KDS Garment Industries Ltd. (11099)

20.APRIL.2014

Identified Priority 1 Concerns

1st Priority 1 Concern

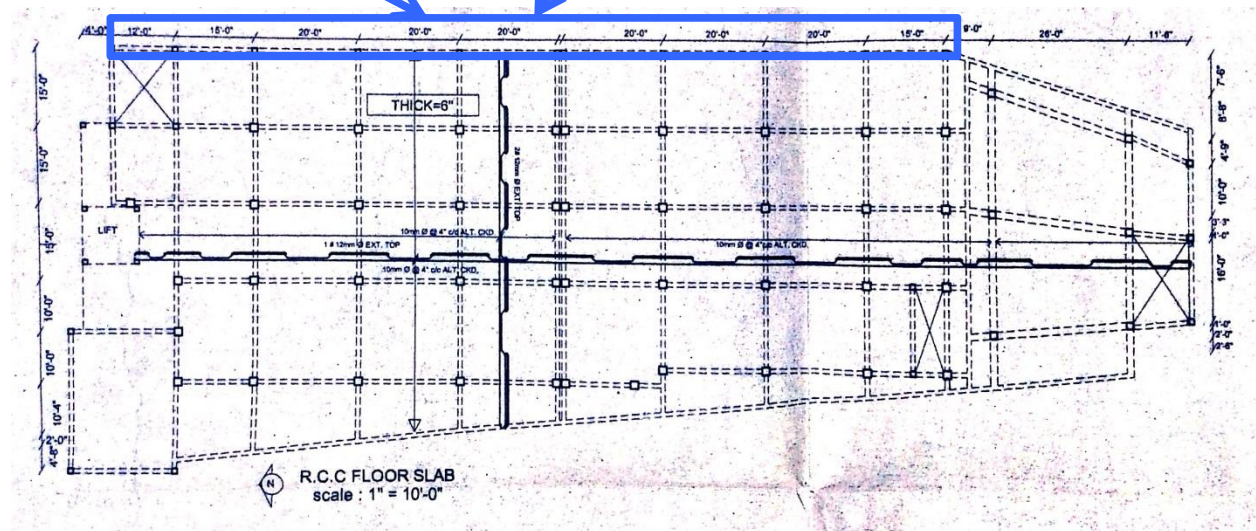
There are cantilevered slabs for rain protection that do not appear on the Building 1 drawings.

- Factory Engineer to survey the actual conditions and revise the drawings.
- Factory Engineer to review design, loads and columns stresses to confirm suitability for loads applied.

1st Priority 1 Concern

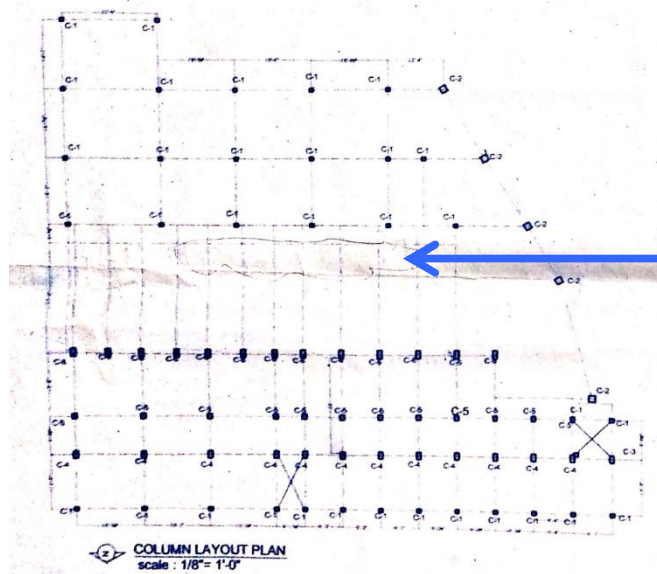
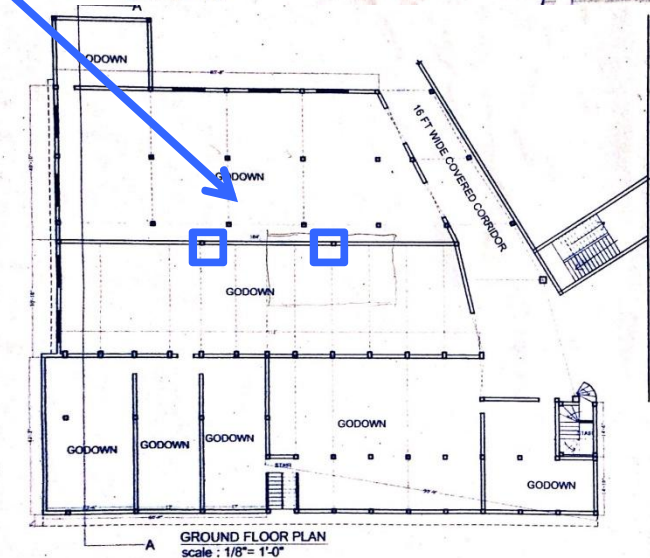
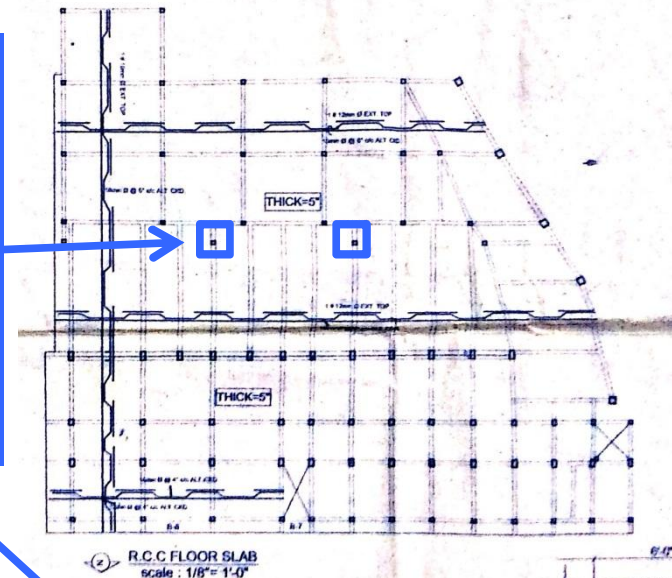
There are 2 columns that do not appear on Building 3 column layout or the foundation layout but they can be found on the slab layout and floor plan.

It is unclear whether the ground floor columns are in the line of wall. But columns were not found on 1st floor. Factory engineer should survey and revise the drawings.

1st Priority 2 Concern

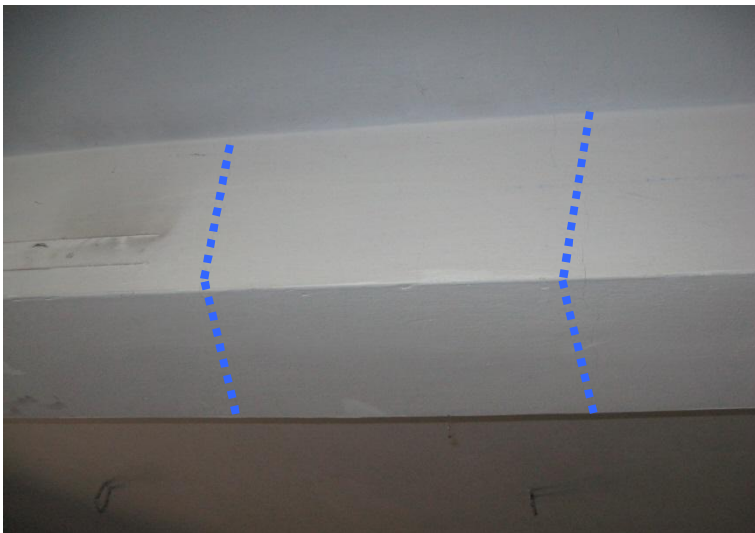
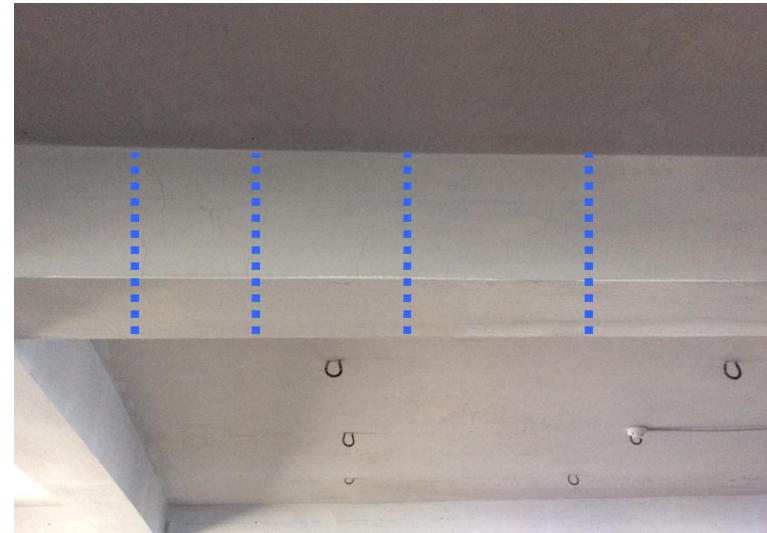
There are cracks found on the underside of beams in Building 1 and Building 2.

There are no movement joints between Building 1 and Building 2 or between Building 1 and Building 3. Cracks were found in the floor finishes between Building 1 and Building 2.

- A Detailed Engineering Assessment of this area is to be carried out.
- The distress found is to be suitably repaired and the cause rectified.

3rd Priority 2 Concern

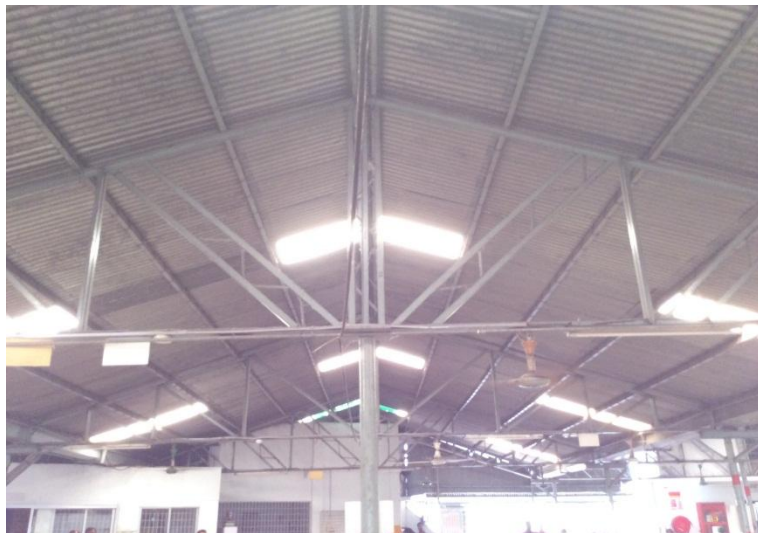
Structural steel elements of Building 3 and the Shed – it is not clear if fire proofing material is applied or is required.

- Fireproofing material for structural steel element is recommended based on Bangladeshi BNBC regulations.
